Morecambe Offshore Windfarm: Generation Assets Examination Documents

The Applicant's Response to Spirit Energy Deadline 1 Submissions Appendix A: The Applicant's Comments on Spirit Energy and Harbour Energy Aviation Access Study Report

Document Reference: 9.35.1

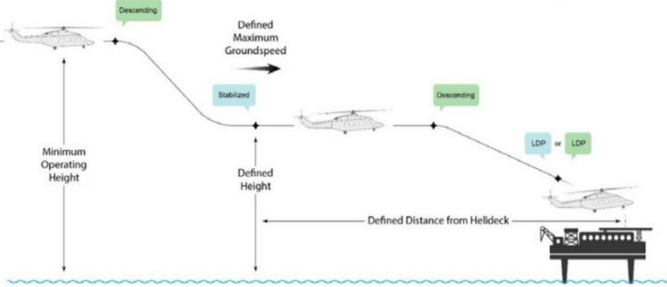
| Comment ID | AviateQ Text | Applicant's Comment |
|------------|------------------------------------------------------------------------------------------------------------------------------------------------------------------------------------------------------------------------------------------------------------------------------------------------------------------------------------------------------------------------------------------------------------------------------------------------------------------------------------------------|----------------------------------------------------------------------------------------------------------------------------------------------------------------------------------------------------------|
| 7.2 | 7.2 Helicopters Turning Around in a HPZc In the event of an abnormal or emergency situation arising whilst enroute, the pilot may need to execute a 180 ^o turn inside the corridor. The space required is determined by calculating the radius of the turn which depends on both the rate of turn (bank angle i.e. how quickly the heading changes) and the airspeed. When airspeed increases the turn radius increases. When the rate of turn increases, the turn radius | As the HAR and dDCO applies distances from the turbine tip at worst-case orientation, the discussion about the HPZc is not required. It is standard practice to reduce airspeed when close to obstacles. |

| Comment ID | AviateQ Text | Applicant's Comment |
|------------|----------------------------------------------------------------------------------------------------------------------------------------------------------------------------------------------------------------------------------------------------------------------------------------------------------------------------------------------------------------------------------------------------------------------|------------------------------------------------------------------------------------------------------------------------------------------------------------------------------------------------------------------------------------------------------------------------------------------------------|
| |  <p>Figure 2 HPZc Turning Circle (Arc) @ 80 kts and a 150 (Rate One Turn) Bank Angle = 1,295m + Obstacle Clearance (2 x 153m) 1,600m. (Arc = 2xr)</p> | |

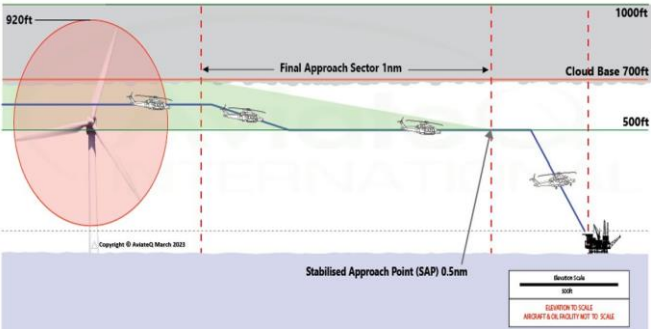
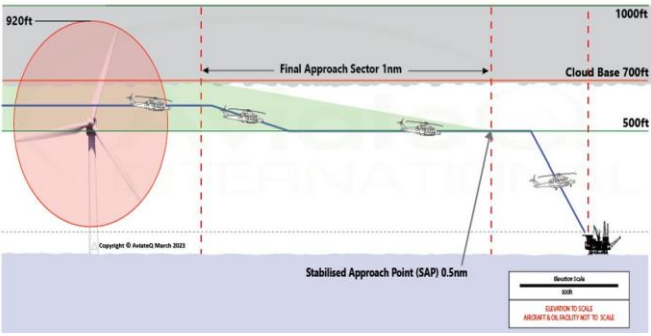
| Comment ID | AviateQ Text | Applicant's Comment |
|------------|--------------------------------------------------------------------------------------------------------------------------------------------------------------------------------------------------------------------------------------------------------------------------------------------------------------------------------------------------------------------------------------------------------------------------------------------------------------------------------------------------------------------------------------------------------------------------------------------------------------------------------------------------------------------------------------------------------------------------------------------------------------------------------------------------------------------------------|--------------------------------------------------------------------------------------------------------------------------------------------------------------------------------------------------------------------------------------------------------------------------------------------------------------------------------------------------------------------------------------------------------------------------------------------------------|
| 7.3 | <p>7.3 Calculating the Radius of Turn An accepted formula, $r = V^2 / g \tan \phi$ where: r = radius of turn (m) $g = 9.81 \text{ m/s}^2$ $V = \text{true airspeed (kts)}, \phi = \text{Angle of bank (}^\circ\text{)}$ Based on an airspeed of 80kts and a 15⁰ angle of bank (Rate One Turn -3° per second based on autopilot function) the radius of turn would be 647m (0.35nm). As can be determined from Figure 2 below, the turning circle requires a minimum distance of 1,295m. Allowing for an obstacle clearance requirement of 500ft (153m) either side of the corridor equates to an overall unobstructed corridor width of 1,600m.</p> | <p>The formula is agreed.</p> <p>This section seems to be considering flight within a wind farm, which is not required. If flight inside the wind farm is needed, this width of corridor is not required, as the helicopter would offset to one side before making a turn, as is done when flying in a valley, up the Thames Heli-lanes etc. The Hornsea Four Johnston Wellheads Protected Provisions (PPs) can be used as an example⁴.</p> |

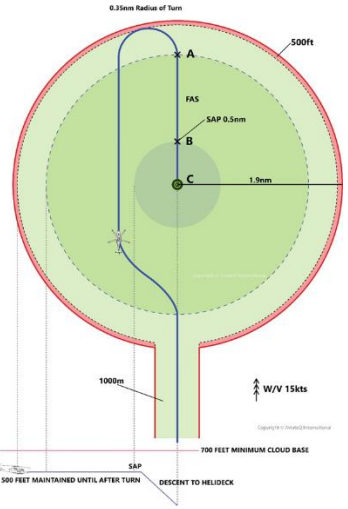
| Comment ID | AviateQ Text | Applicant's Comment |
|------------|----------------------------------------------------------------------------------------------------------------------------------------------------------------------------------------------------------------------------------------------------------------------------------------------------------------------------------------------------------------------------------------------------------------------|------------------------------------------------------------------------------------------------------------------------------------------------------------------------------------------------------------------------------------------------------------------------------------------------------|
| 8.1 | <p>8. VFR OPERATING CONSIDERATIONS in an HPZf 8.1 Stabilised Approaches A helicopter approaching a landing point must make a stabilised approach. The purpose of a stabilised approach is to ensure the helicopter is in the correct configuration and on the correct flight path for landing, with gear down, and groundspeed at the correct value for the conditions. The aim is</p> | <p>What the AviateQ Report requires is a pre-stabilisation point at 1.5nm before the actual stabilisation point at 0.5nm. This is not consistent with industry guidance or current practice. In fact, under current industry guidance a turn can be made up to the stabilisation point at 0.5nm.</p> |

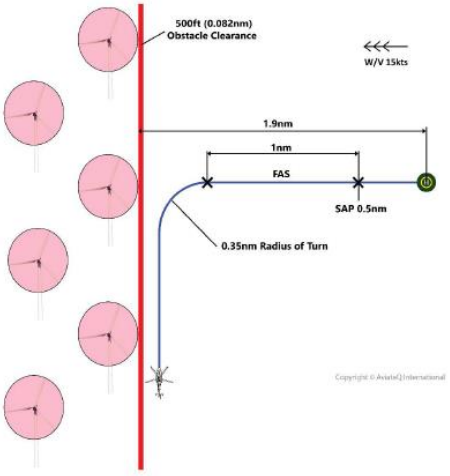
| Comment ID | AviateQ Text | Applicant's Comment |
|------------|---------------------------------------------------------------------------------------------------------------------------------------------------------------------------------------------------------------------------------------------------------------------------------------------------------------------------------------------------------------------------------------------------------------------------------------------------------------------------------------------------------------------------------------------------------------------------------------------------------|------------------------------------------------------------------------------------------------------------------------------------------------------------------------------------------------------------------------------------------------------------------------------------------------------------------------------------------------------------------------------------------------------------------------------------------------------------------------------------------------------------------------------------------------------------------------------------------------------------------------------------------------------------------------------------------------------|
| 8.2 | <p>8.2 Entering a HPZf VFR with a Tailwind and Positioning onto the Approach to Land</p> <p>Due to variations in wind directions consideration has been given to the possibility of a tailwind when entering the HPZf and the distance taken to position the helicopter onto the final approach track, into wind, including the radius of turn.</p> <p>As can be seen from Figure 6 below, a Final Approach Sector (A-B) of 1 nm allows the pilot time to make heading changes ensuring the helicopter is into wind and within the stabilised approach criteria by the 0.5nm SAP (B).</p> | <p>The term HPZf is not used in aviation regulations or guidance. With a tailwind, the diagram shows the worst possible flight profile as during the 180° turn onto the final approach, the pilots will not have sight of the wind turbines near their tail. A pilot would actually turn sooner and aim to roll out facing into wind shortly before the stabilisation point. That was agreed with the helicopter operator for access to the Waveney Platform in the Sheringham and Dudgeon Extension DCO.</p> <p>The distance shown of 1.9nm is only required because of the pre-stabilisation point at 1.5nm, which has no basis in regulation, industry guidance or current practice. Evidence</p> |

| Comment ID | AviateQ Text | Applicant's Comment |
|------------|--------------------------------------------------------------------------------------------------------------------------------------------------------------------------------------------------------------------------------------------------------------------------------------------------------------------------------------------------------------------------------------------------------------------------------------------------|--------------------------------------------------------------------------------------------------------------------------------------------------------------------------------------------------------------------------------------------------------------------------------------------------------------------------------------------------------------------------------------------------------------------------------------------------------------------------------------------------------------------------------------------------------------------------------------------------------------------|
| | <p>If the helicopter is not in a stabilised configuration on arrival at the SAP the pilot is obliged to execute a missed approach. These manoeuvres are taking place under a minimum cloud base of 700ft. The distance required to execute this manoeuvre including a 500ft (0.08nm) obstacle clearance, results in a total minimum requirement of 1.9nm.</p>  | <p>from current practice and the Sheringham and Dudgeon Extension DCO shows that a distance of 1.26nm is sufficient for a day VMC approach. This is based on: a conservative stabilisation point at 0.75nm; a radius of turn of 0.43nm when flown at 80kt; and a 0.08nm (500ft) obstacle clearance ($0.75 + 0.43 + 0.08 = 1.26\text{nm}$).</p> <p>The Applicant's Response to Spirit Energy Deadline 1 Submissions Appendix C: Helicopter Supporting Information Technical Note (Document Reference 9.35.3) provides further details on the required approach distances.</p> |

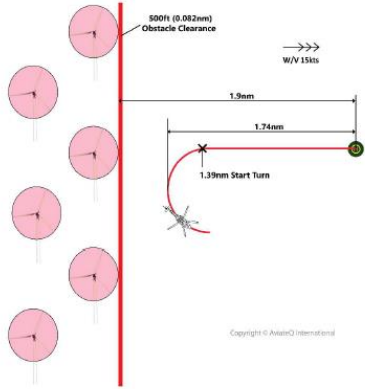
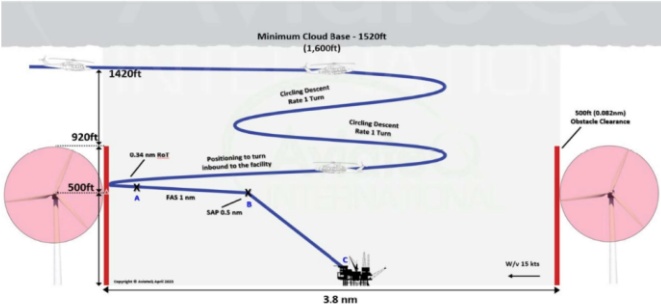
| Comment ID | AviateQ Text | Applicant's Comment |
|------------|--------------------------------------------------------------------------------------------------------------------------------------------------------------------------------------------------------------------------------------------------------------------------------------------------------------------------------------------------------------------------------------------------------------------------------------------------|--------------------------------------------------------------------------------------------------------------------------------------------------------------------------------------------------------------------------------------------------------------------------------------------------------------------------------------------------------------------------------------------------------------------------------------------------------------------------------------------------------------------------------------------------------------------------------------------------------------------|
| 8.3 | <p>8.3 Engine Failure at Take-off Decision Point and OEI Climb to 500ft VMC</p> <p>Climb to 500ft is stated as taking 1.76nm.</p> | <p>The AviateQ report applies Sea Level ISA (International Standard Atmosphere) conditions of 1013 hPa and 15°C. 15kts of wind is used. The Applicant has also used 1013 hPa and</p> |

| Comment ID | AviateQ Text | Applicant's Comment |
|------------|------------------------------------------------------------------------------------------------------------------------------------------------------------------------------------------------------------------------------------------------------------------------------------------------------------------------------------------------------------------------------------------------------------------------------------------------------------------------------------------------------------------------------------------------------------------------------------------------------------------------------------------------------------------------------------------------------------------------------------------------------------------------------------------------------------------------------------------------------------------------------------------------------------------------------------------------------------------------------------------------------------------------------------------------------------------------------------------------------------------------------------------------------------------------------------------------|----------------------------------------------------------------------------------------------------------------------------------------------------------------------------------------------------------------------------------------------------------------------------------------------------------------------------------------------------------------------------------------------------------------------------------------------------------------------------------------------------------------------------------------------------------------------------------------------------------------------------------------------------------------------------------------------------------------------------------------------------------------------------------------------------------------------------------------------------------------------------------------------------------------------------------------------------------------------------------------------------------------------------------------------------|
| | <p>The distance required to safely execute a continued take off on one engine following an engine failure on rotation at the Take-off Decision Point (TDP) in the AW169 has been calculated based on the following: (Figure 7A)</p> <ol style="list-style-type: none"> 1. Drop down height 2. Acceleration from the Take-off Decision Point (TDP) to Take Off Safety Speed (Vtoss) with a positive Rate of Climb (CTO) 3. Path 1 climb from end of CTO to 200ft at Vtoss. 4. Level acceleration from Vtoss to Vy. 5. Path 2 climb from 200ft to 500ft at Vy. 6. Rate one turn at 500ft 7. Pressure altitude of 0ft, temperature of 15C, wind velocity of 15kts 8. All heights are Above Take-off Surface (ATS). <p>Section 1: Acceleration from TDP to Vtoss and positive ROC (CTO)</p> <ul style="list-style-type: none"> ▪ 9ft drop down due head wind factor. <i>(Graph 54T-D15}</i> ▪ Distance required is 350m or 0.19nm. <i>(Section 4- Performance data -OE/ Continued Take-off Distance)</i> <p>Section 2: Path 1 Climb from end of CTO to 200ft</p> | <p>15°C but has used a range of wind conditions typical of those experienced in Morecambe Bay.</p> <p>The take-off mass applied in the AviateQ Report was 4800kg. However a more realistic take-off mass is 4650 kg or lower. The Applicant identifies the take-off distances required for a range of aircraft mass and wind conditions in 4.2 and 4.3 in The Applicant's Response to Spirit Energy Deadline 1 Submissions Appendix C: Helicopter Supporting Information Technical Note (Document Reference 9.35.3).</p> <p>Section 2 shows drag penalties (Graph S4-6) are applied to the AviateQ Flightpath 1 climb performance calculations. Flightpath 1 requires the landing gear to be lowered and so this is not correct.</p> <p>The Applicant's calculations of the take-off distances required for a range of aircraft mass and wind conditions are shown in The Applicant's Response to Spirit Energy Deadline 1 Submissions Appendix C: Helicopter Supporting Information Technical Note (Document Reference 9.35.3).</p> |

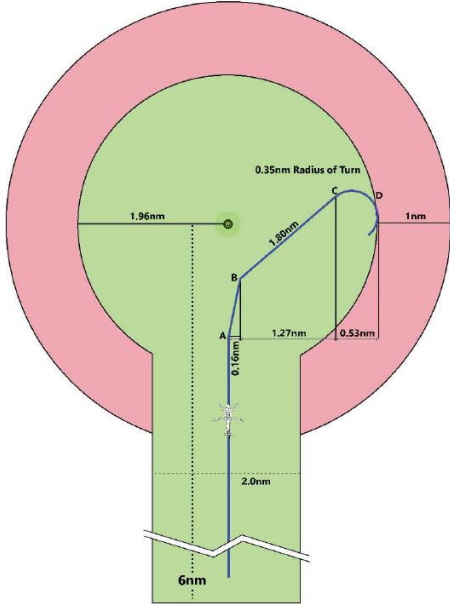
| Comment ID | AviateQ Text | Applicant's Comment |
|------------|-------------------------------------------------------------------------------------------------------------------------------------------------------------------------------------------------------------------------------------------------------------------------------------------------------------------------------------------------------------------------------------------------------------------------------|---------------------------------------------------------------------------------------------|
| 8.4b | <p>Departure from Adjacent Facility with Engine Failure at TDP With the wind blowing from the windfarm array at 90° to the array boundary, space is required for the helicopter to depart the adjacent facility, to climb to 500ft and turn away from the obstructions. The worst case scenario is an engine failure just after the Take-Off Decision Point (TDP) when departing the elevated helideck.</p> | <p>This section repeats the calculated distance of 1.76nm. See comments to section 8.3.</p> |

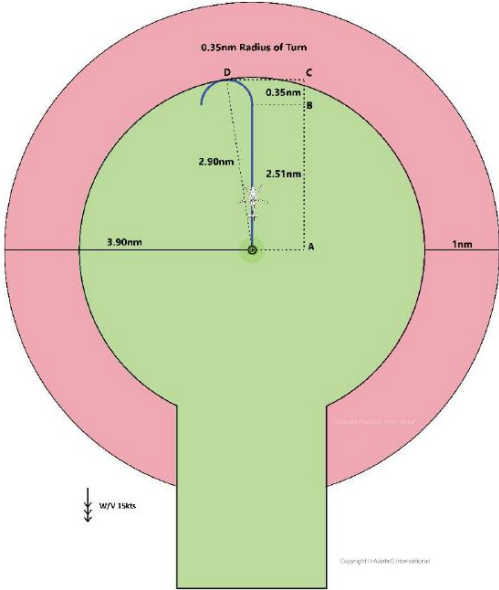
| Comment ID | AviateQ Text | Applicant's Comment |
|------------|-----------------------------------------------------------------------------------------------------------------------------------------------------------------------------------------------------------------------------------------------------------------------------------------------------------------------------------------------------------------------------------------------------------------------------------------|--------------------------------------------------------------------------------------------------------------------------------------------------------------------------------------------------------------------------------------------------------------------------------------------------------------------------------------------------------------------------------------------------------------------------------------------------------------------------------------------------------------------------------|
| 9.5 | <p>9.5 Engine Failure at ARA Missed Approach Point and Climb OEI to 1,000ft In the event of an engine failure on reaching the Missed Approach Point (MAPt) the pilot will execute a 30° turn away from the facility and commence a climb at Vv to 1000ft, followed by a Rate One Turn through 180° while continuing the climb to the Minimum Sector Altitude (MSA) i.e. 1000ft above</p> | <p>The Applicant's Response to Spirit Energy Deadline 1 Submissions Appendix C: Helicopter Supporting Information Technical Note (Document Reference 9.35.3) demonstrates that the offset at 1.5nm from the installation, and any Missed Approach will be orientated away from the platform.</p> |

| Comment ID | AviateQ Text | Applicant's Comment |
|------------|--------------------------------------------------------------------------------------------------------------------------------------------------------------------------------------------------------------------------------------------------------------------------------------------------------------------------------------------------------------------------------------------------------------------------------------------------------------------------------|-----------------------------------------------------------------------------------|
| | <p>the height of the wind turbines. The distances required as shown in Figure 13 below equates to a radius of 1.96nm. Adding the 1nm obstacle clearance in IMC brings the total distance required to 2.96 nm.</p>  <p style="text-align: center;">Figure 13 <i>AW169 Distance Required OEI Climb from ARA MAPt to 1000 ft & turn through 180° inside the HPZf</i></p> | <p>Therefore, the distance to complete a Missed Approach is always available.</p> |

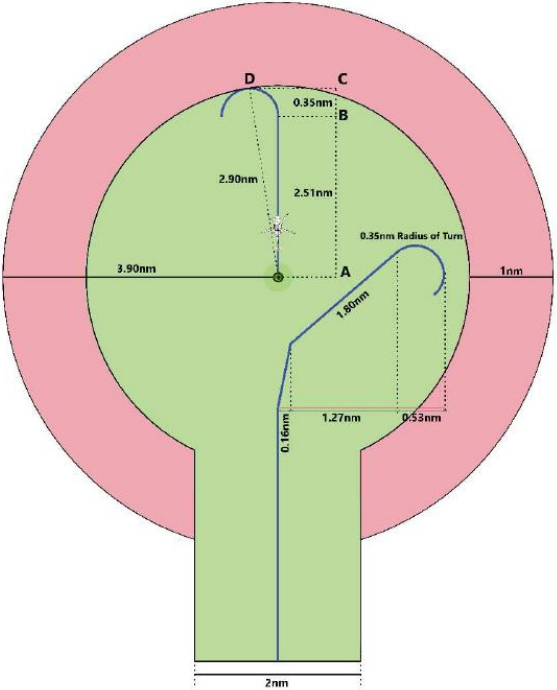
| Comment ID | AviateQ Text | Applicant's Comment |
|------------|----------------------------------------------------------------------------------------------------------------------------------------------------------------------------------------------------------------------------------------------------------------------------------------------------------------------------------------------------------------------------------------------------------------------------------------------------------------------------------------------------------------------------------------------------------------------------------------------------------------------------------------------------------------------------------------------------------------------------------------------------------------------------------------------------------------------------------|--------------------------------------------------------------------------------------------------------------------------------------------------------------------------------------------------------------------------------------------------------------------------------------------------------------------------------------------------------------------------------------------------------------------------------------------------------------------------------------------------------------------------------------------------------------------------------------------------------------------------------------------------------------------------------------------------------------------------------------------------------------------------------------------------------------------------------------------------------------------------------------|
| 9.6.1 | <p>The total distance required for OEI TDP to 1000ft would be the sum of the 4 sections namely 0.19nm + 0.16nm + 0.36nm + 1.80nm = 2.51nm.</p> <p>Rate One Turn at 1000 ft (IFR) The total distance required from TDP / OEI to 1000ft and 180° turn taking into consideration the displaced apex of the Rate one Turn = 2.90 nm. (Figure 14B) Minimum distance required would need to include the legal obstacle clearance requirement of 1nm for IFR flight and therefore minimum distance required is 3.90nm. On completion of the turn the aircraft will continue to climb to the Minimum Sector Altitude (MSA) i.e., 1000ft above the tips of the turbine rotor blades. Note: the MSA will vary depending on the height of the assembly.</p> | <p>For the reasons stated above, these distances are considered to be excessive.</p> <p>In particular:</p> <ul style="list-style-type: none"> ▪ The maximum aircraft mass of 4,800kg used by AviateQ in their calculations is unlikely. A mass of 4600kg and lower is more probable, as there is no offshore refuelling capability the helicopter's take-off mass will continue to decrease as the flight progresses. If eight passengers are carried from Blackpool Airport to CPC-1, then any subsequent take-offs from CPC-1 will be at 4,650kg or lower. A fuller explanation of the take-off mass is shown in Section 4.3 of The Applicant's Response to Spirit Energy Deadline 1 Submissions Appendix C: Helicopter Supporting Information Technical Note (Document Reference 9.35.3). ▪ Some minor errors on the drag penalty to apply has been made. |

| Comment ID | AviateQ Text | Applicant's Comment |
|------------|--------------------------------------------------------------------------------------------------------------------------------------------------------------------------------------------------------------------------------------------------------------------------------------------------------------------------------|-------------------------------------------------------------------------------------------------------------------------------------------------------------------------------------------------------------------------------------------------------------------------------------------------------------------------------------------------------------------------------------------------------------------------------------------------------------------------------------------------------------------------------------------------------------------------------------------------------------------|
| | <p style="text-align: center;">AW169 - Engine Failure at TDP with climb to 1000ft(IFR) (ISA and WV 15kts) 4800kg</p>  <p style="text-align: center;">Figure 14A AW169 Profile View Distance Required OEI Climb to 1,000ft</p> | <ul style="list-style-type: none"> A major difference is that the climb should be to 1,000ft above sea level and not 1,184ft (1,000ft plus the height of the CPC-1 helideck). Applying the AviateQ methodology, a shorter distance will be required from any other helideck in the Morecambe Gas Field as they have lower helidecks than CPC-1. <p>The Applicant has calculated the distances required for take-off in Section 4 of The Applicant's Response to Spirit Energy Deadline 1 Submissions Appendix C: Helicopter Supporting Information Technical Note (Document Reference 9.35.3).</p> |
